# Kanter Real Estate, LLC Joint Application for Individual Environmental Resource Permit 3rd RAI Response

Submitted to: Florida Department of Environmental Protection

For: Kanter Real Estate, LLC  
2601 South Bayshore Drive, Suite 1450  
Miami, Florida 33133  
August 17, 2016

## Attachment 1: Preservation Mitigation Proposal

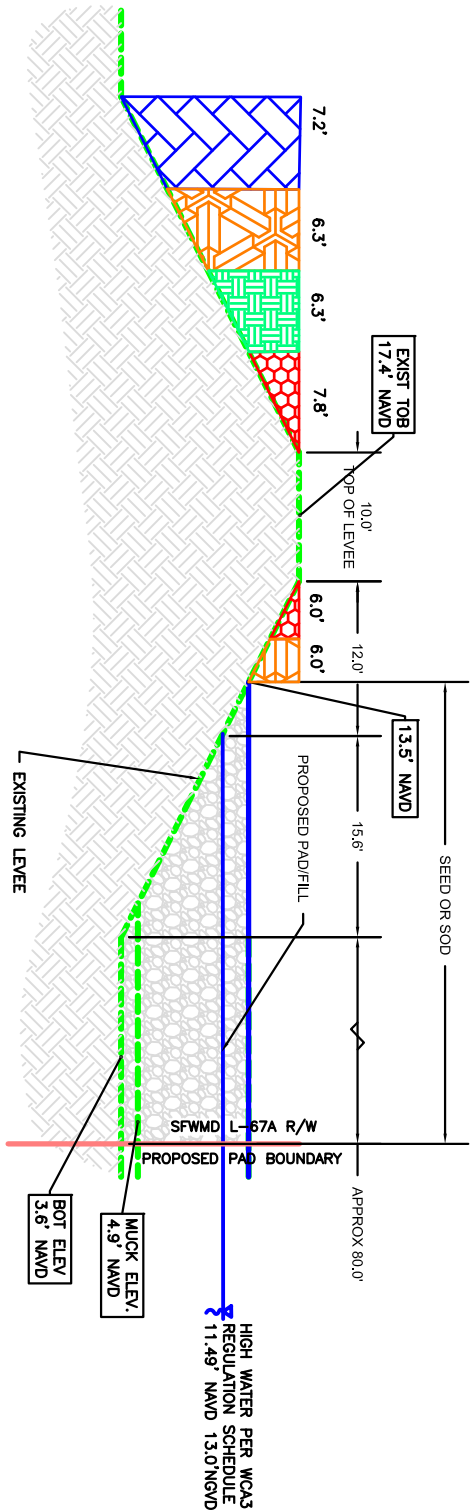
1. **The proposed mitigation plan describes a real property conveyance of other Kanter-owned lands within Water Conservation Area (WCA) 3A South. Although the information does not indicate to whom this property will be conveyed, staff is aware that the applicant proposes to convey the 186 acres of private lands to the SFWMD. As discussed with Carol Howard, these lands are part of the Florida Fish and Wildlife Conservation Commission's Everglades Wildlife Management Area and, among other management activities, are currently managed for invasive exotic vegetation. As part of this management area, active and passive recreational activities (e.g. hunting, airboating, camping, wildlife observation, etc) are authorized. Additionally, the area is also managed for some exotic vegetation by the SFWMD. Furthermore, the area is designated as "Conservation Use" in Broward County Land Use maps. Because of these described activities and designation, staff is unable to assess a development threat or calculate a functional lift for these lands as they are already protected and managed. As such, the proposed mitigation is not appropriate to offset the proposed adverse impacts associated with the project.**

**Staff acknowledges that you are exploring other mitigation options as a result of discussions with Ms. Howard. Please submit an appropriate mitigation plan that adequately offsets the proposed adverse impacts. If mitigation credits will be proposed, then please contact Monica Sovacool to verify the number of credits and submit a letter of reservation from an appropriate mitigation bank verifying that the sufficient amount of credits have been reserved.**

The applicant proposes two options for mitigation. Within one month of construction, the applicant will either purchase credits within the Hole in the Donut Mitigation Bank or, if state credits are not available at that time, execute a conservation easement to the Florida Department of Environmental Protection for parcel described in the attached proposal for mitigation by donation. Kanter's donation proposal, preservation adjustment factor analysis, and UMAM Worksheet Parts I and II for preservation are included as **Attachment 1**.

## Attachment 2: Planting Plan

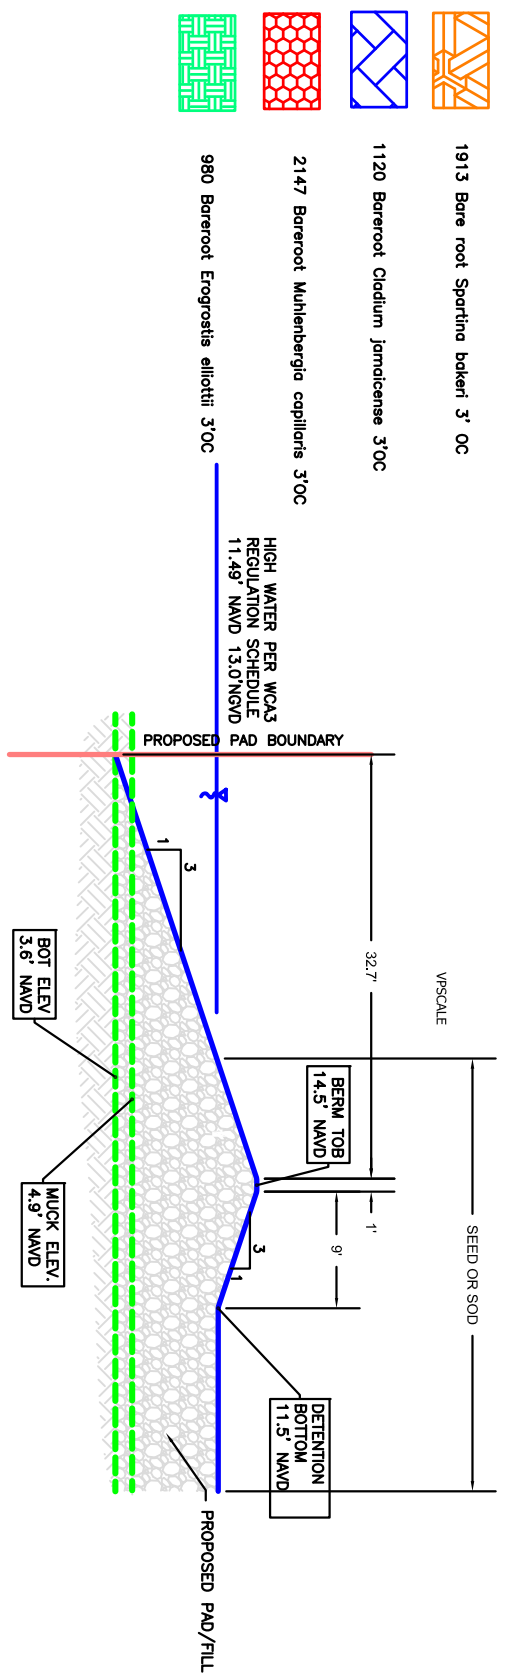
2. **The submitted information describes the use of four native grasses to stabilize the berm around the project area. In order provide assurance the vegetation is appropriate to stabilize the berm, please provide details for the planting plan, including location and number of plants per species and planting densities. A separate exhibit/drawing may be submitted or the submitted plans may be revised to show the plantings.**

Please see **Attachment 2** for a drawing of the planting plan with the requested details.

- 1913 Bare root *Spartina bakeri* 3' OC
- 1120 Bareroot *Cladium jamaicense* 3'OC
- 2147 Bareroot *Muhlenbergia copilifera* 3'OC
- 980 Bareroot *Erogrostis Elliottii* 3'OC
